Site Plan Review Committee (SPRC)

March 10, 2025

2500 Wilson Boulevard

Major Site Plan Amendment (SP #220)

Wilson Boulevard Façade (North Elevation)

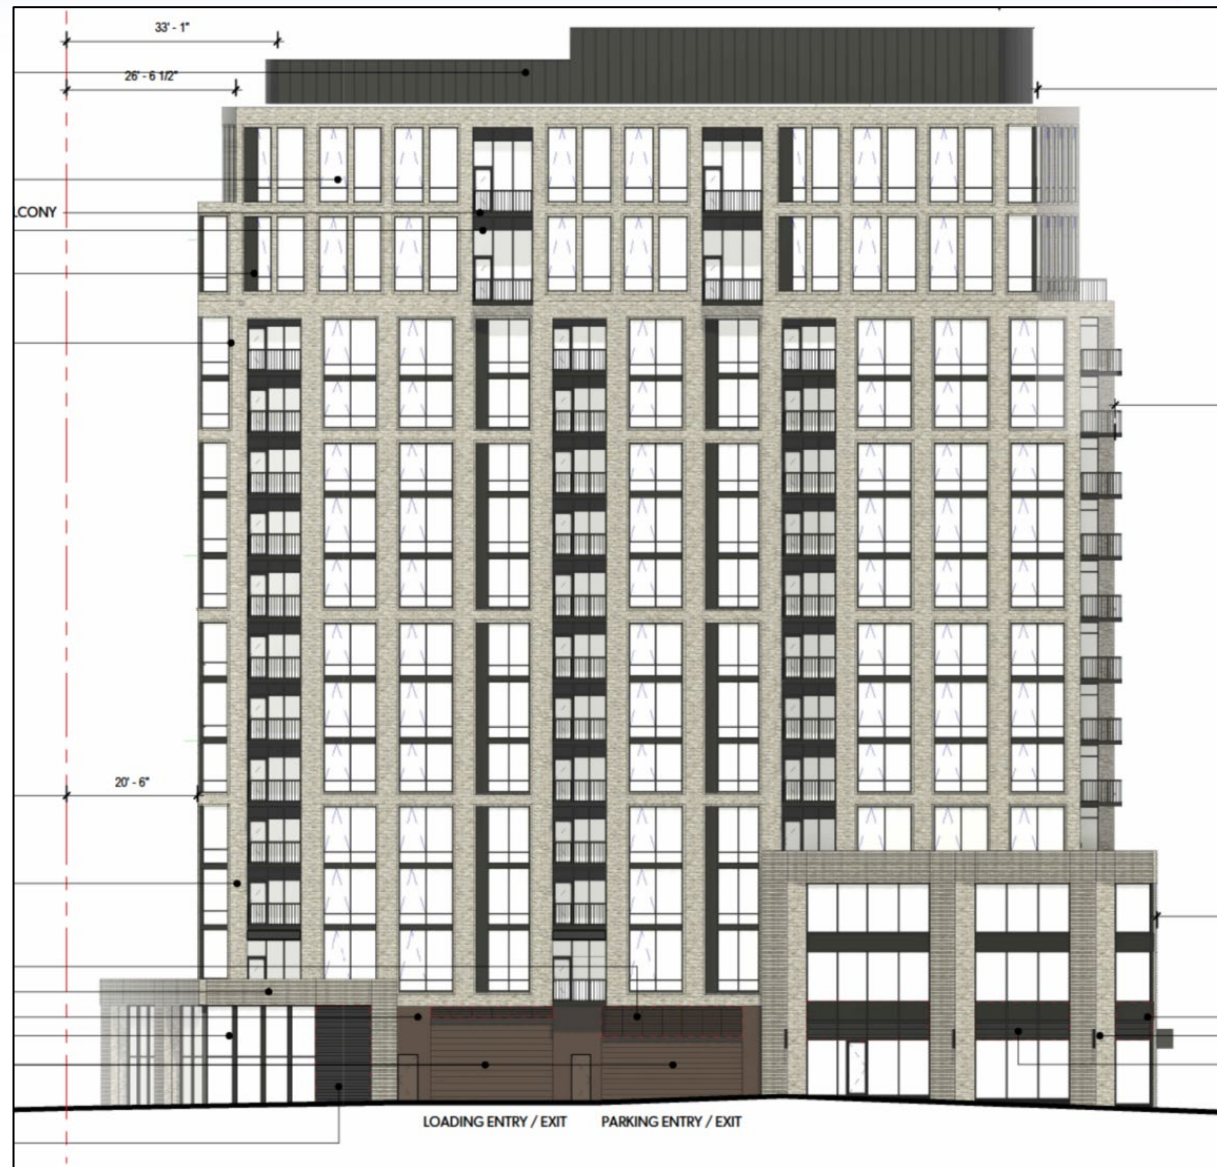
Deviations from Guidance

- Heights of 4-6 stories along North Cleveland Street
- Use of different materials to distinguish between top, middle and bottom
 - However, applicant uses stepbacks, changes in massing, and fenestration to distinguish a top, middle and base

North Cleveland Street Façade (West Elevation)

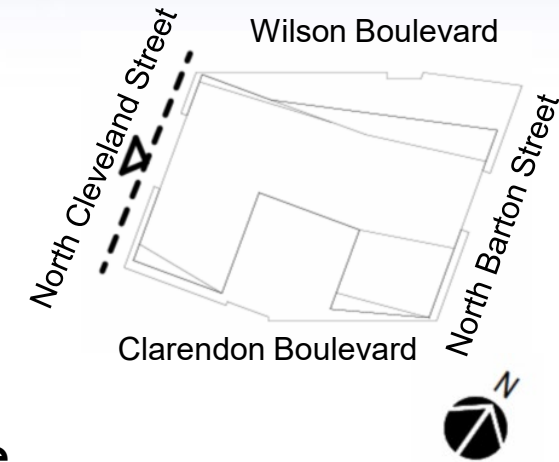
Deviation from Guidance

- Along the North Cleveland Street frontage, building heights of 4 to 6 stories could be appropriate
 - No stepback on the North Cleveland Street façade on the 4th floor
